Informal document GRSP-56-40
(56th GRSP, 9-12 December 2014,
agenda item 16)

Proposal of amendments to ECE/TRANS/WP.29/GRSP/2014/31

Proposal for Supplement 1 to the 01 series of amendments to Regulation No. 127 (Pedestrian safety)

Submitted by the expert from the European Commission as Chair of the Task Force on Bumper Test Area within the Informal Working Group on global technical regulation No. 9 Phase 2*

"Figure 5A

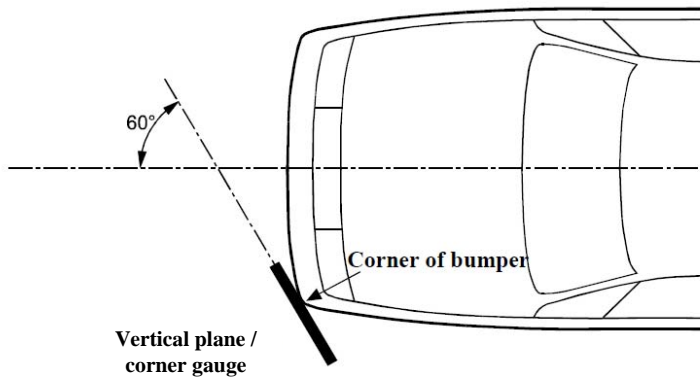
Figure 5, amend to read:

Corner of bumper example (see paragraph 2.16., note that the corner gauge is to be moved in vertical and horizontal directions to enable contact with the outer contour/
front fascia of the vehicle)

"2.16. *"Corner of bumper"* means **the transversal position of the vehicle's point of contact with a vertical plane which makes an angle of 60° with the vertical longitudinal plane of the vehicle and is tangential to the outer surface of the bumper (see Figure 5).** ~~corner gauge as defined in Figure 5B.~~

For determination of the corner of bumper, the front surface of the corner gauge is moved parallel to a vertical plane with an angle of 60° to the vertical longitudinal centre plane of the vehicle (see Figures 5A and 5C) at any height of the centre point of the corner gauge in the following area:

- (a) **Equal to and above the point found on the vertical line intersecting the Lower Bumper Reference Line at the assessment position in transversal direction or at 75 mm above the ground reference plane, whichever is higher.**
- (b) **Equal to and below the point found on the vertical line intersecting the Upper Bumper Reference Line at the assessment position in transversal direction or at 1,003 mm above the ground reference plane, whichever is lower.**

For determination of the corner of bumper, the gauge is moved to contact the outer contour/front fascia of the vehicle touching at the vertical centre line of the gauge. The horizontal centre line of the gauge is kept parallel to the ground plane.

The corners of bumper on both sides are subsequently defined as the outermost points of contact of the gauge with the outer contour/front fascia of the vehicle as determined in accordance with this procedure. Any points of contact on the top and the bottom edges of the gauge are not taken into account. The rear and side view mirrors and the tyres shall not be considered."
